21 East meadow st. HAWP 35/13-08 m  
Cherry Chase

Staff Item  
Anne Fothergill  
~~July 9, 2008~~  
JUL 25,

**MONTGOMERY COUNTY HISTORIC PRESERVATION COMMISSION**  
**STAFF REPORT**

<b>Address:</b>	21 East Melrose Street, Chevy Chase	<b>Meeting Date:</b>	5/14/08
<b>Resource:</b>	Contributing Resource Chevy Chase Village Historic District	<b>Report Date:</b>	5/07/08
<b>Applicant:</b>	Susan Gallagher (Anne Decker, Architect)	<b>Public Notice:</b>	4/30/08
<b>Review:</b>	HAWP	<b>Tax Credit:</b>	None
<b>Case Number:</b>	35/13-08M	<b>Staff:</b>	Anne Fothergill
<b>PROPOSAL:</b>	Rear addition and alterations to windows

Left Elevation - New

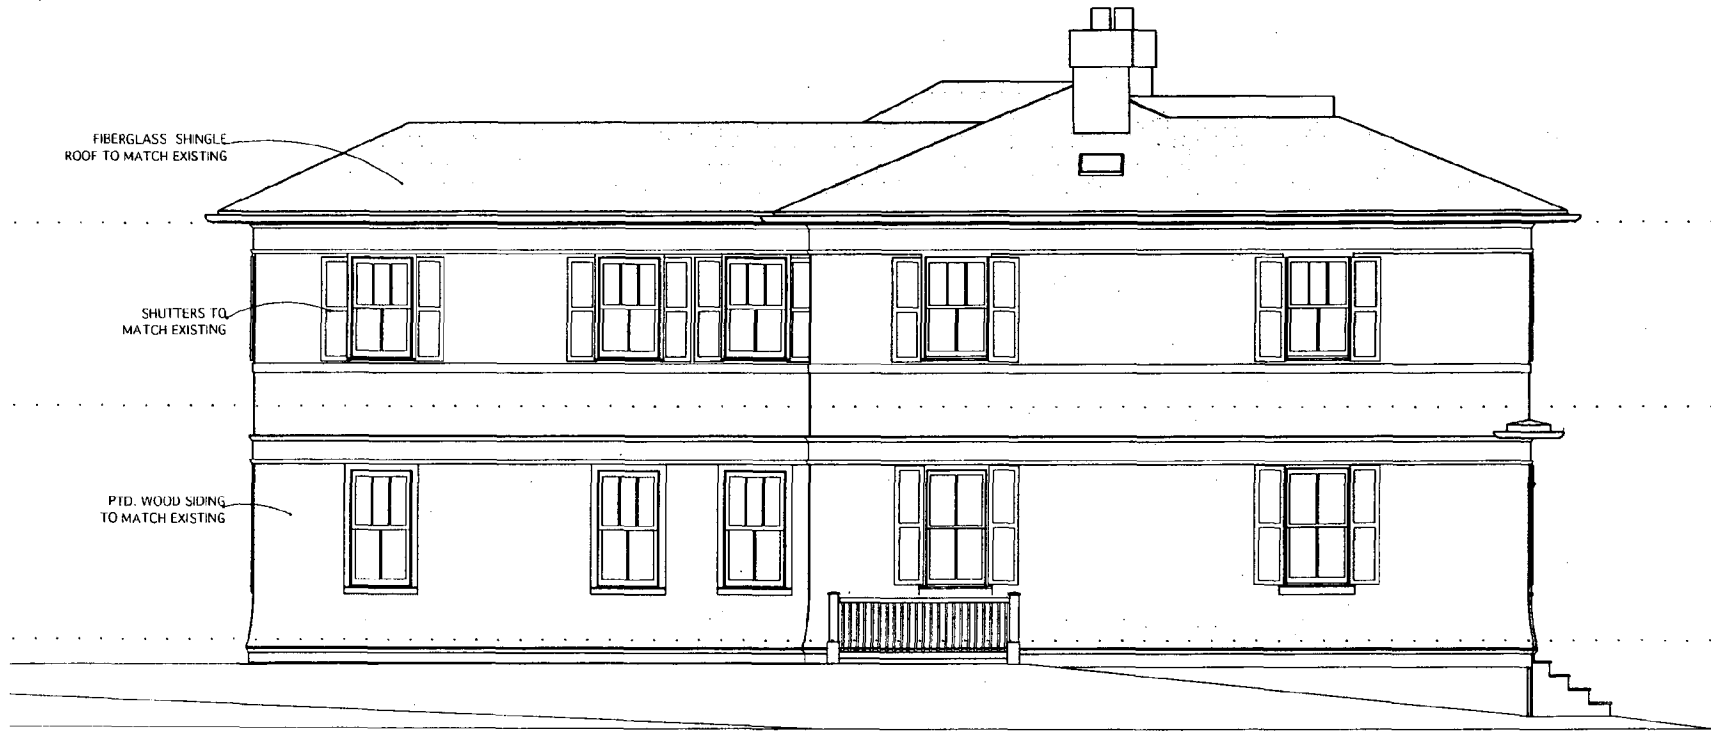
In May 2008 the HPC approved an addition and alterations to 21 East Melrose Street, Chevy Chase. The HPC did not allow two new windows in the historic massing (circle 2) but recommended that the applicants install a skylight on the left side and an additional window in the new addition. The HPC said that the revised side elevation would need to come back to the Commission as a staff item (circles 3 + 5). Staff is requesting that the HPC approve this revised elevation.

*Proposed in HAWP (not approved)*

revised based on HPC's guidance

Right Elevation - New

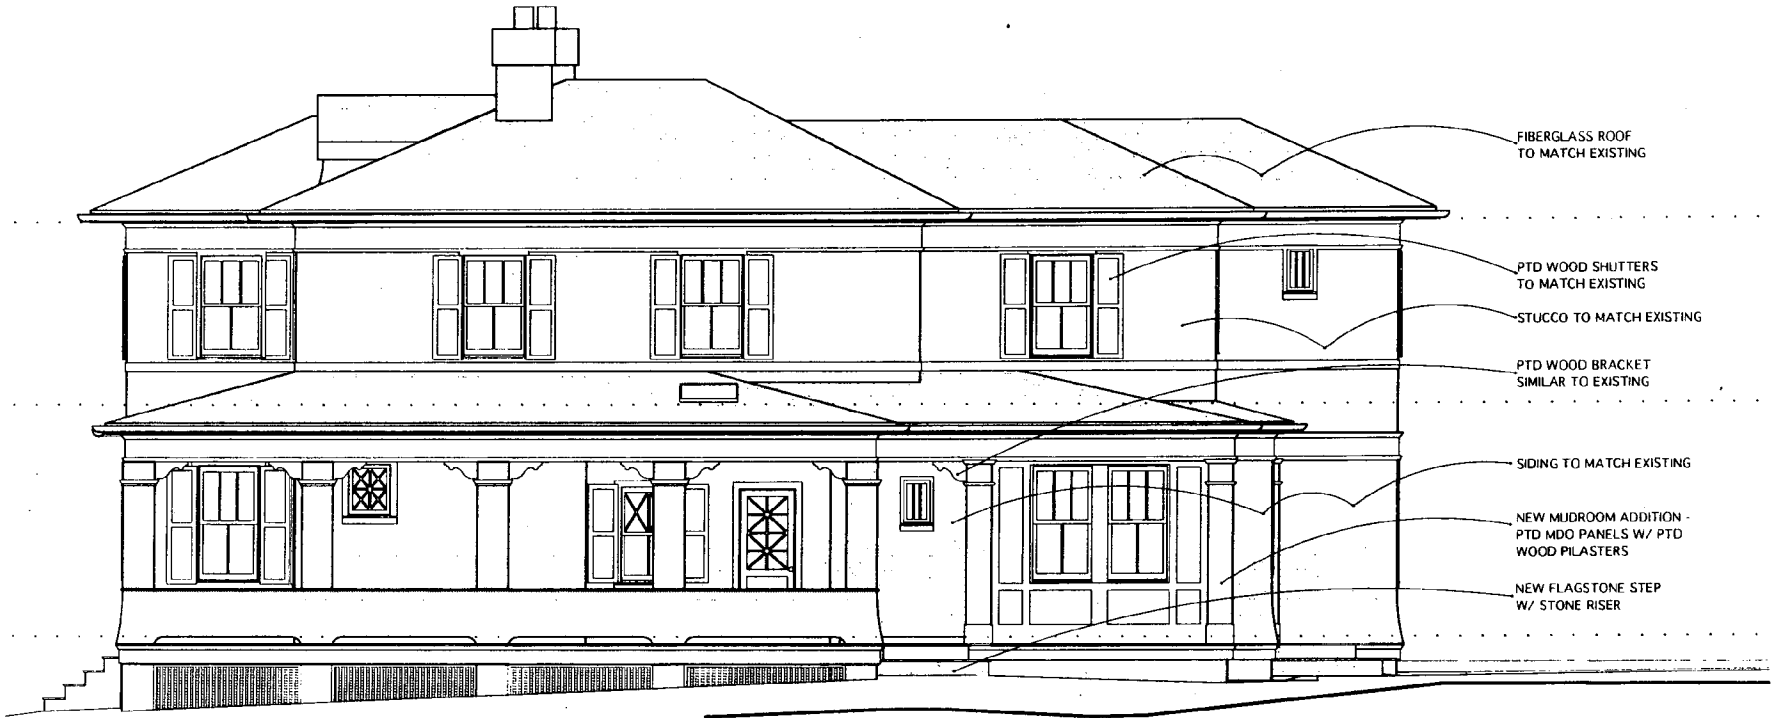
The applicants also would like to install a skylight in the roof of the wraparound porch. If the HPC allows this installation, staff will stamp this new elevation too. circles 6 + 7

*new porch skylight proposed*

Existing Left Elevation

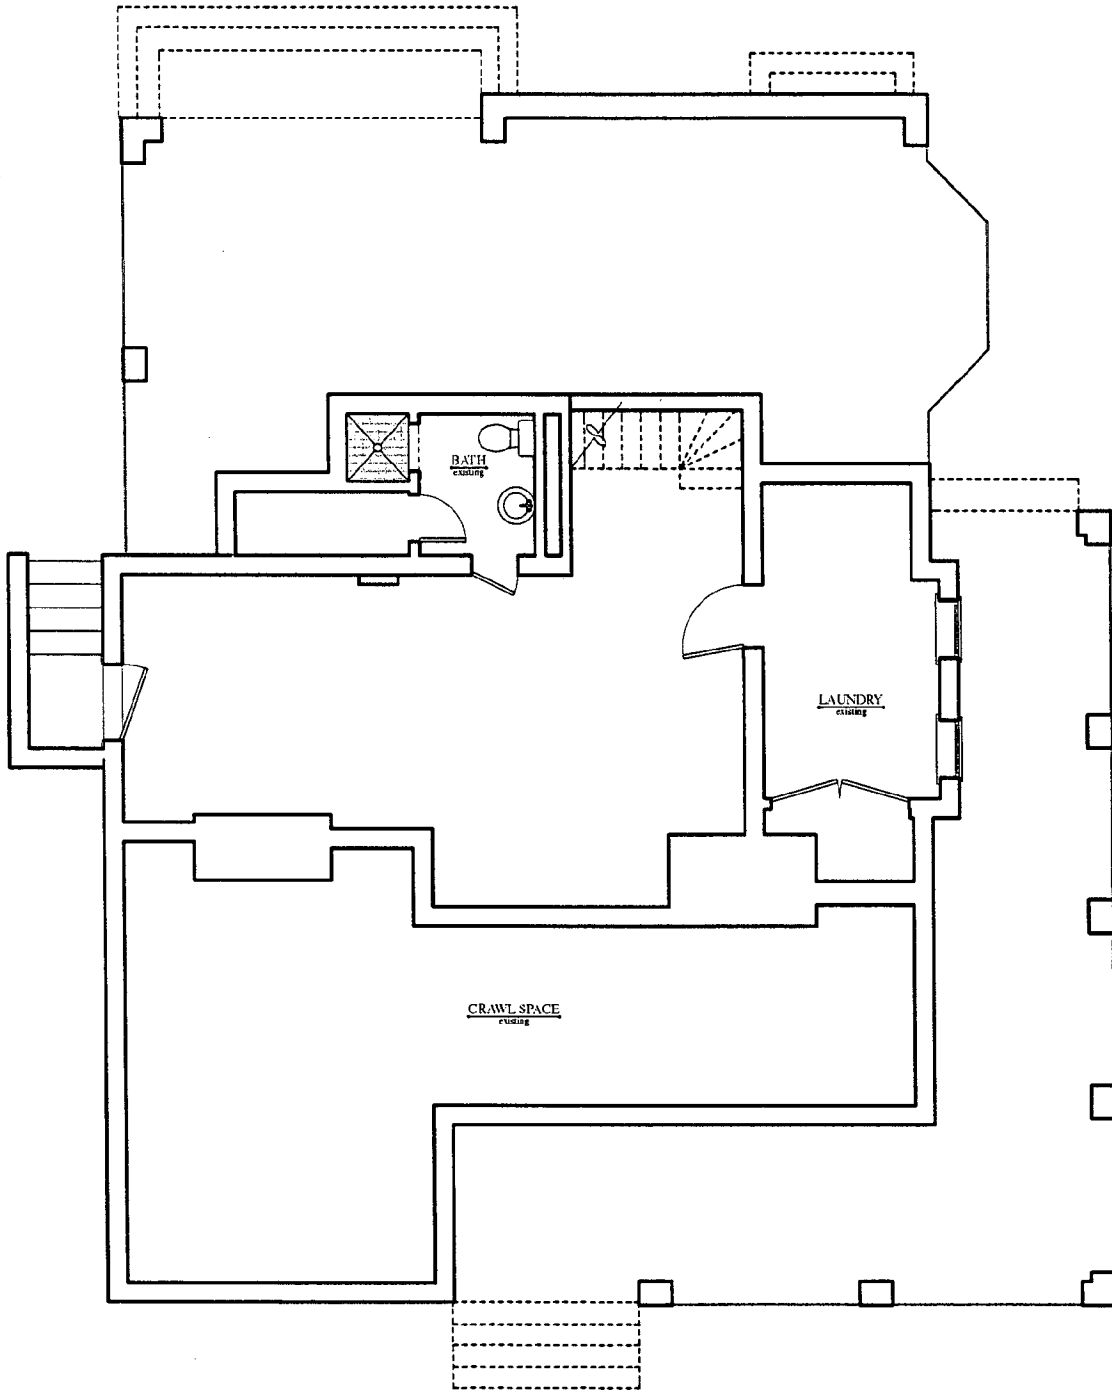
1. The installation of two windows on the left side of the historic house is not approved.

However, the alterations that staff cannot support are the proposed two new window openings on the left side of the historic house. The Secretary of the Interior's *Guidelines for Rehabilitating Historic Buildings* state: "As one of the few parts of a building serving as both an interior and exterior feature, windows are nearly always an important part of the historic character of a building. In most buildings, windows also comprise a considerable amount of the historic fabric of the wall plane and thus are deserving of special consideration in a rehabilitation project." The Secretary of the Interior's *Guidelines* recommend against: "Changing the number, location, size or glazing pattern of windows, through cutting new openings, blocking-in windows, and installing replacement sash that do not fit the historic window opening." Salvaging original windows is a good idea when possible, but staff cannot support adding two new window openings to the historic massing and suggests that perhaps the salvaged windows could be incorporated into the new addition.
